Access Compliance Report Public Rights-of-Way (Pedestrian Signals)

Main Street: **NEWPORT_AVE** Cross Street: **FOOTHILL_BLV** Location: **W**

ADA ID: **SGAT211018093748** Signal Type: **One Push Button-Non APS** Overall Compliance: **No** Severity Scores: **BTN 1: 25** **BTN 2: N/A** **No BTN: N/A**

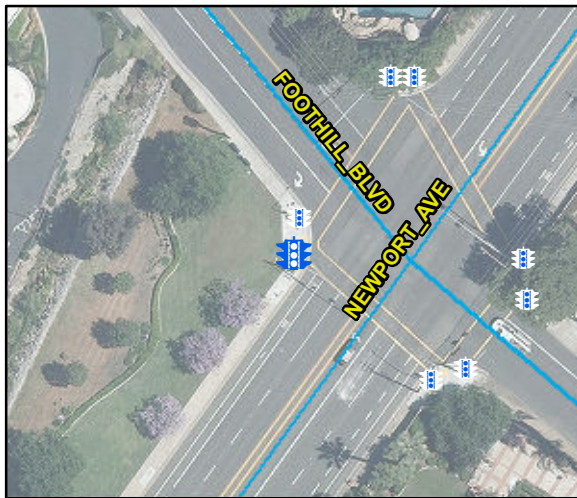
OC Std/PROW: **R404.2**

Possible Solutions: Remove and Replace Clear Space.
